Re: 2015 Comprehensive Performance Test (CPT) Results  
Response to Comments

## Response to April 1, 2016 Comments on Norlite CPT Report and NOC

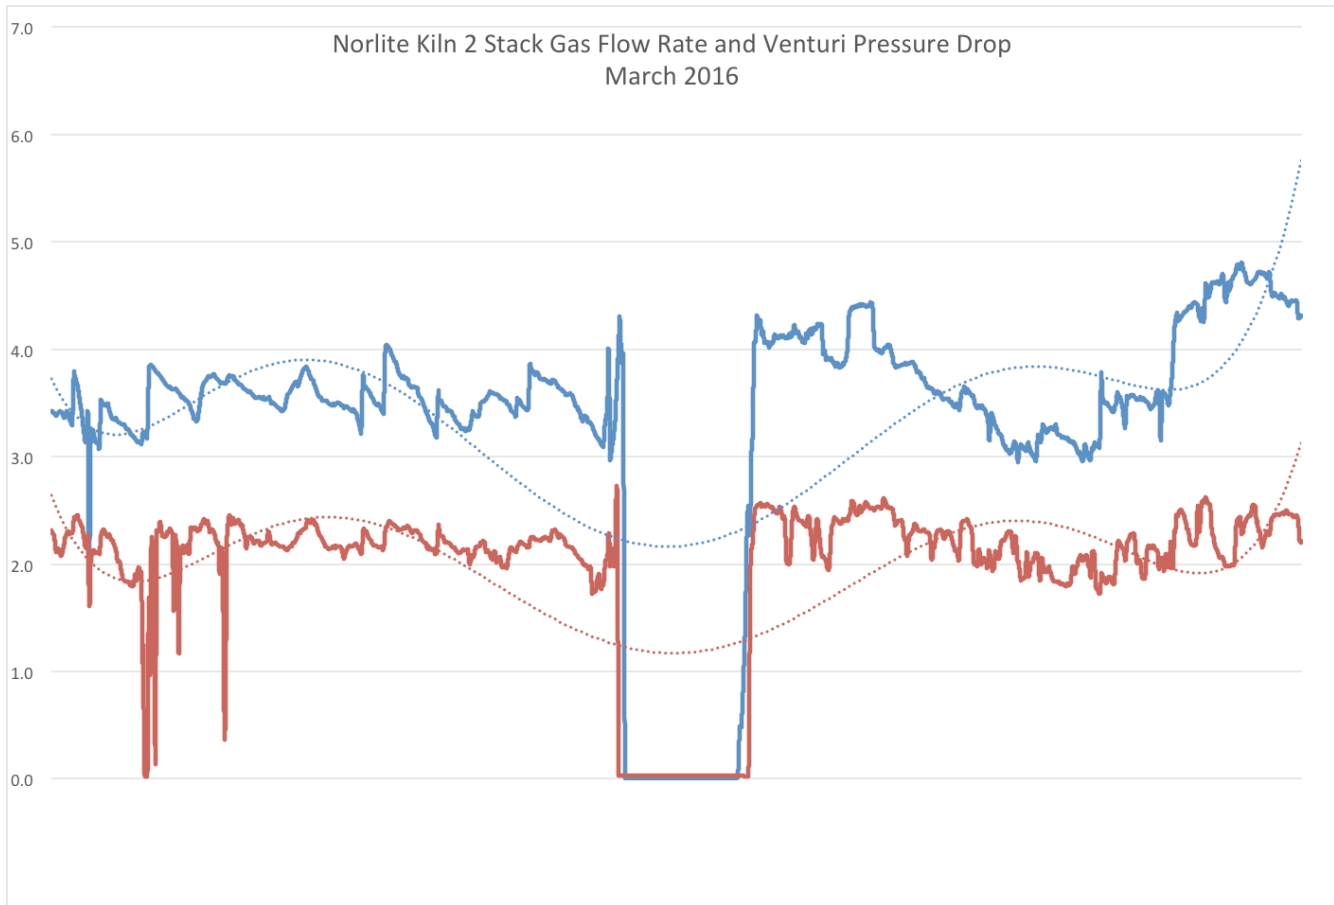
The Department's April 1, 2016 comment document discusses how Norlite used a mixture of operating parameter limits (OPLs) derived from Conditions 2 and 3 to demonstrate compliance with the MACT standards for metals, PM and HCl/Cl<sub>2</sub> and that the two conditions, together, do not represent normal operating conditions for the kilns. Rather, Conditions 2 and 3 represent two different modes of operation of the kilns and separate OPLs would be required for each mode of operation as described in 40 CFR 63.1207(g). As such, the Department is requiring Norlite to set OPLs based on Condition 2 or Condition 3.

While the values presented in Tables 2-2 for these parameters appear to be very different, they are still represent the middle of their respective operating ranges. For example, the operating “window” for the stack gas flow rate during the test was between 33,103 and 25,490 scfm. The complete operating range for stack gas flowrate is approximately 17,000 scfm to 48,555 scfm based on the maximum operating capacity of the 400 hp induction fan. The resulting venturi scrubber pressure drop over the full range of the induction fan’s operating curve would be between approximately 1.5 in w.c. and 8.0 in w.c.. Norlite’s established operating “window” is between 2.9 in w.c. and 6.1 in w.c.. We believe that this meets the intent of “extreme range of normal conditions” and does not represent different modes of operation. To support this conclusion, we present the table below.

The table is a plot of data from Kiln 2 for the full month of March 2016 for the stack gas flowrate and the venturi pressure drop. The stack gas flowrate (shown in red) has been divided by 10,000 in order to get it to appear on the same plot as the venturi pressure drop (shown in blue). Trend lines are provided for convenience. It is very evident that the correlation between the two data sets is very good. One does not move without the other. If the values were to change disproportionately, it would be an indication that the expected scrubber efficiency would be different at different flowrates. This does not appear to be the case. The emissions of the target contaminants are well below the MACT standards at both ends of this defined operating range so it is more than reasonable to conclude that the same removal can be expected throughout the defined operating range.
